Technical Specification	Title	Page(s)
3/4.7.6	Control Room Subsystems-Air Conditioning	3/4 7-18a

3/4.7.6 CONTROL ROOM SUBSYSTEMS

License Amendment Request (LAR) 99-19 proposes a one-time only change to the action statements of Seabrook Station Technical Specification 3.7.6.2. In modes 1, 2, 3, and 4, the proposed change would allow North Atlantic 60 days (on a one-time basis) to restore one inoperable Control Room Air Conditioning Subsystem (CRACS) to OPERABLE status or be in at least HOT STANDBY within the next 6 hours and in COLD SHUTDOWN within the following 30 hours. In modes 5 and 6, the proposed change would allow North Atlantic 60 days (on a one-time basis) to restore the inoperable system to OPERABLE status or initiate and maintain operation of the remaining OPERABLE Control Room Air Conditioning Subsystem or immediately suspend all operations involving CORE ALTERATIONS or positive reactivity changes. Additionally, an exception to the requirements of TS 3.0.4 and Surveillance Requirement 4.0.4 is proposed as they apply to TS 3.7.6.2 during the implementation of the modification to the CRACS.

ENCLOSURE 2 TO NYN-99054

CONTROL
BUILDING AIR
SYSTEM

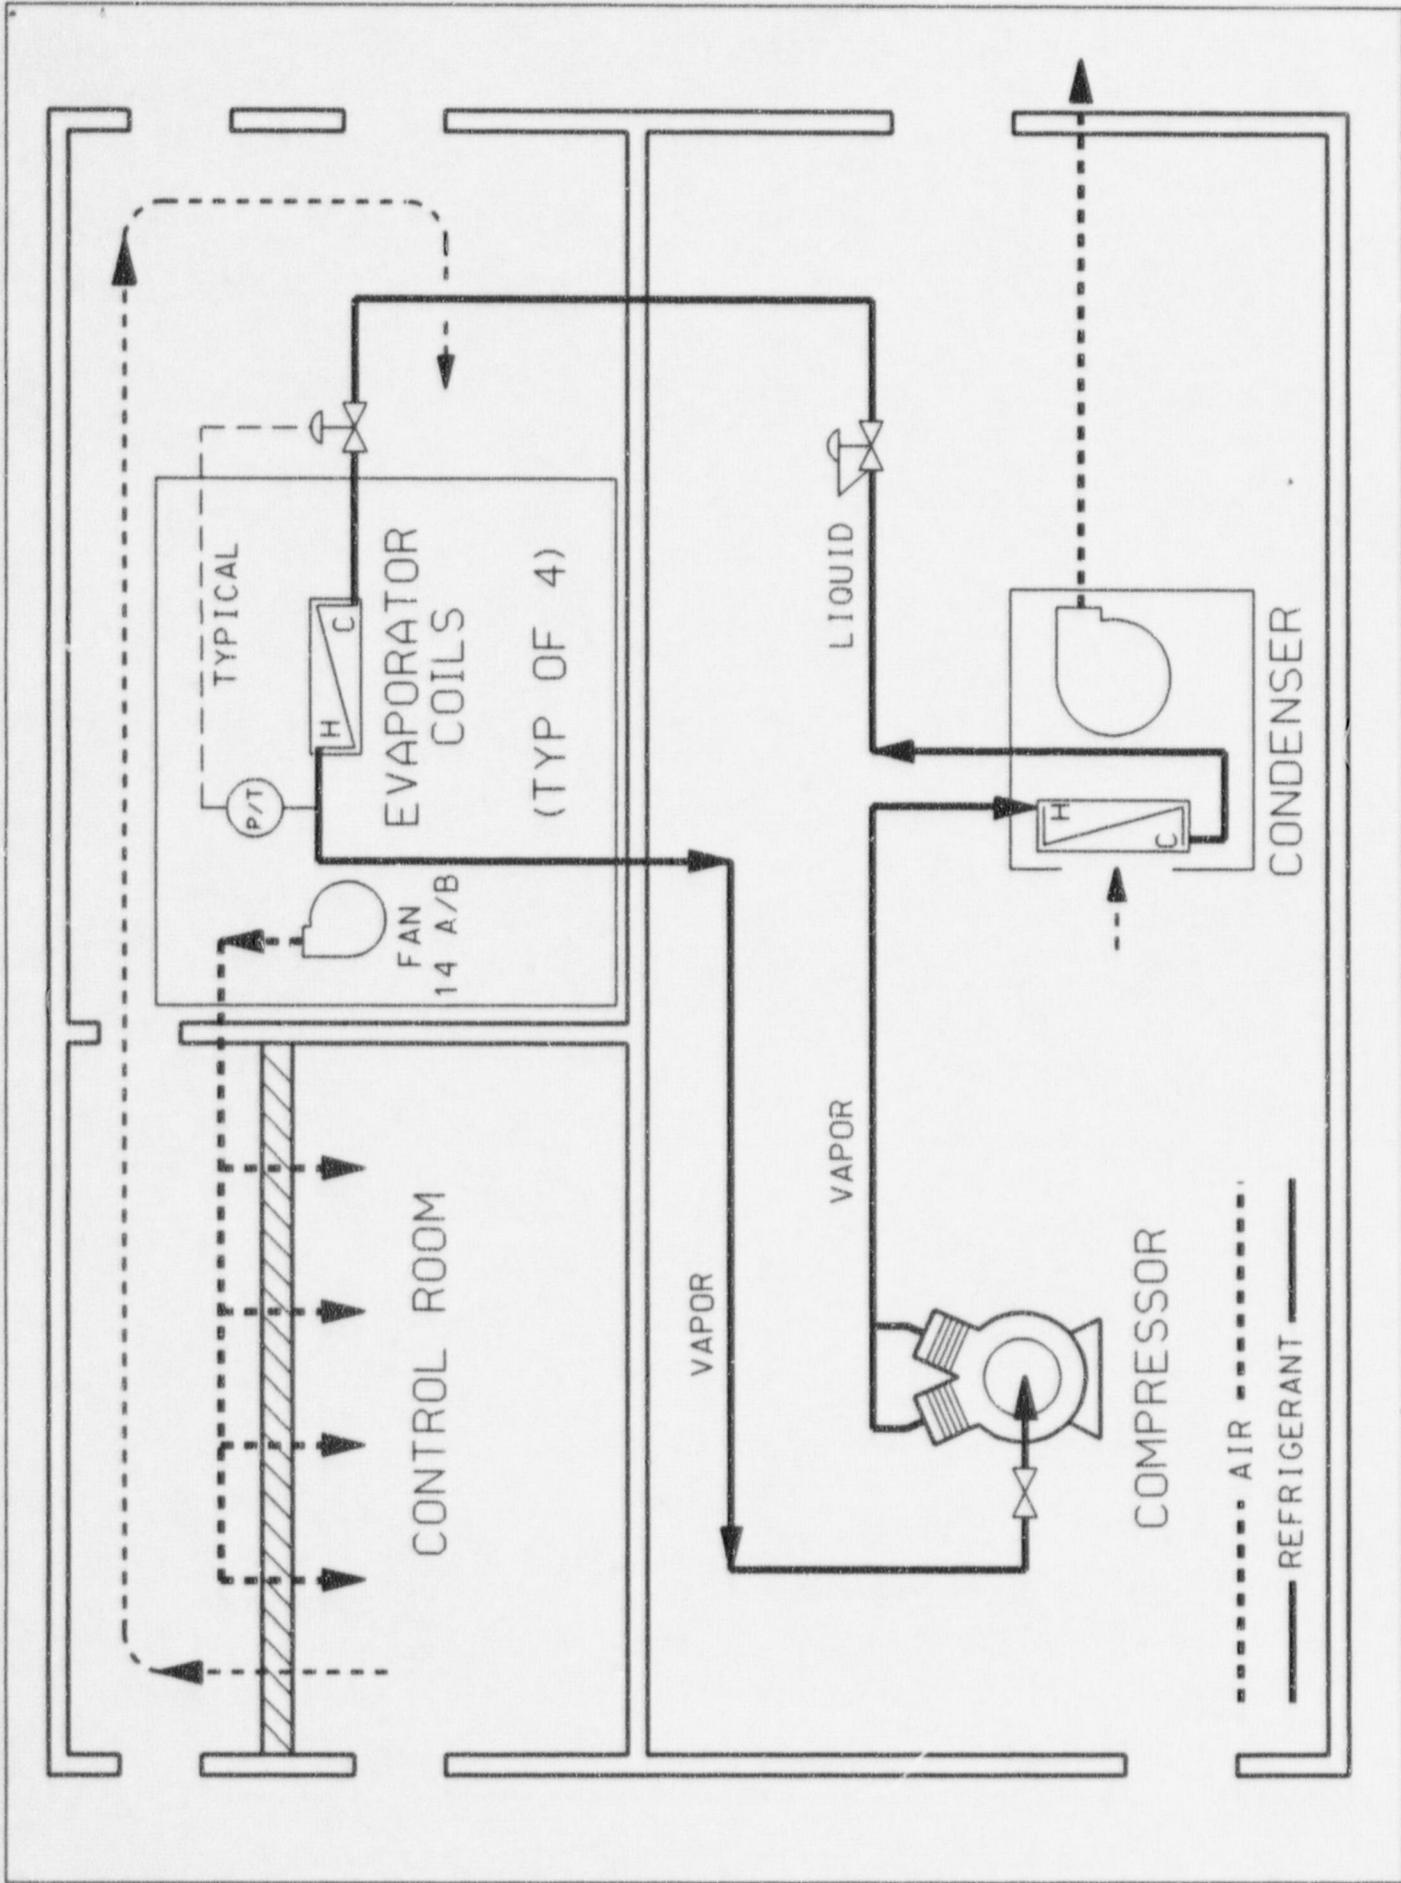
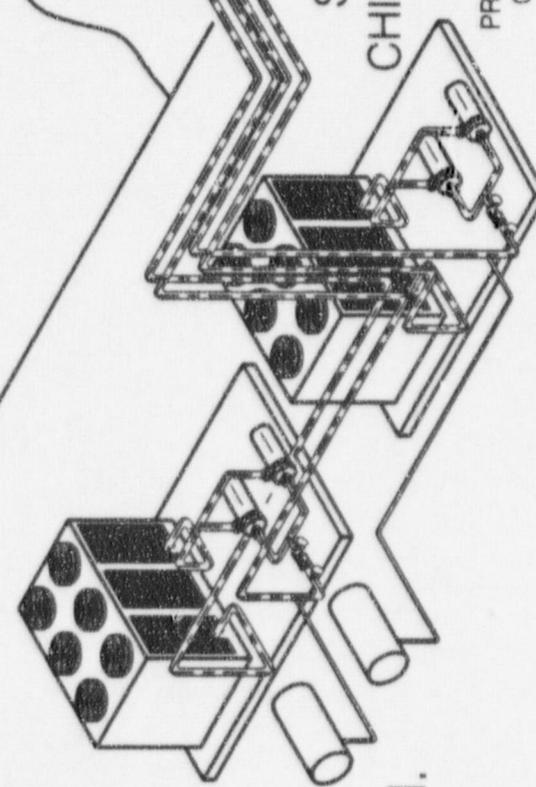
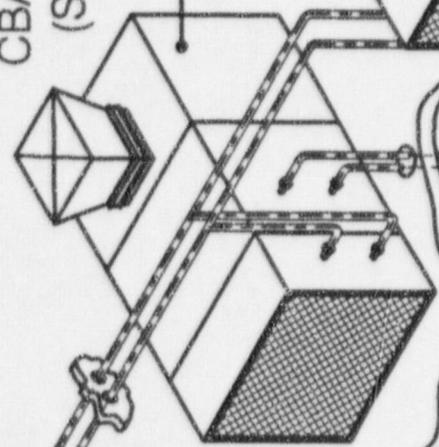
REPLACE
COIL

REPLACE
COIL

REPLACE FILTER &
ADD NS / R COIL

PROPOSED SAFETY-RELATED
CHILLED WATER SYSTEM
